APPLICATION NO.	FILING DATE	FIRST NAMED INVENTOR	ATTORNEY DOCKET NO.	CONFIRMATION NO.
10/650,932	08/28/2003	Thomas J. Baric	2802-455-002	8065

Office Action Summary

This is a first office action on the merits of application SN 10/650,932.

Yasui '935 Figure 1

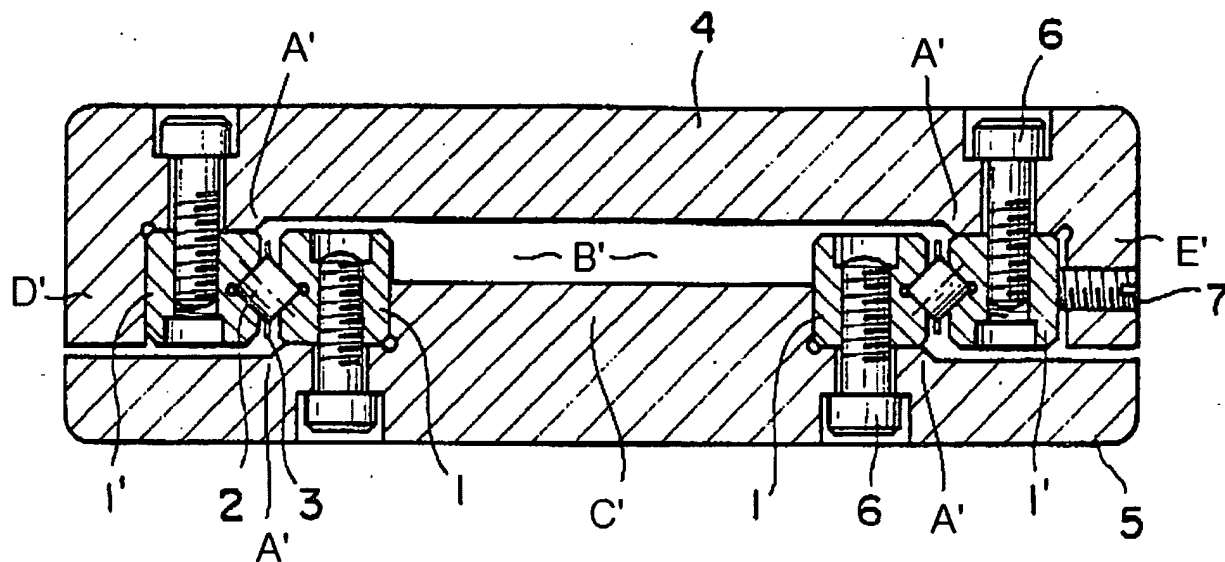
plate (4) being mounted to the base (5) such that the mounting surface of the base is in opposed relation to the mounting surface of the slide plate as shown in Figure 1 below.

9. A pair of bearing assemblies (1, 1', 2, 3, 6) interposed between the base (5) and the slide plate (4), with each bearing assembly including a pair of bearing ways (1, 1') and a rolling element (2, 3) between the bearing ways, with one bearing way (1) from each bearing assembly fixedly secured to the mounting surface of the base (5). The other bearing way (1') of each bearing assembly fixedly secured to the mounting surface of the slide plate. A preload screw (7) is used to give the bearing ways a predetermined preload.

10. Regarding claim 2, each bearing way (1, 1') is supported against the respective lateral mounting surface of the base (5) or slide plate (4) by the screws (6).

11. Regarding claim 3, the base (5) and the slide plate (4) each include short locating ribs (A') projecting outwardly from the flat surfaces of the base (5) and the slide plate (4), respectively, the ribs (A') having a flat surface, and the bearing ways (1, 1') each having a corresponding flat surface located against the flat surface of the ribs (A'), the ribs spacing the bearing ways from the opposed surface of the respective base (5) or slide plate (4) as best seen in figure 1 below.

12. Regarding claim 4 each bearing way (1, 1') comprises an elongated, essentially square component in cross-section, with a rolling element (2) groove in one side surface of the bearing way (1, 1'), and a flat mounting surface on an adjacent side of the bearing way. For claim 5 each bearing way (1, 1') includes another flat side surface opposite the one side surface.

13. Regarding claim 7, the precision parallel device (C', D', E') is located in engaging relation to one of the bearing ways of each bearing assembly. For claim 9 the precision parallel device (C') is located between the inner bearing ways (1). For claim 10 the precision parallel device (D', E') is located on the outside of the outer bearing ways (1').
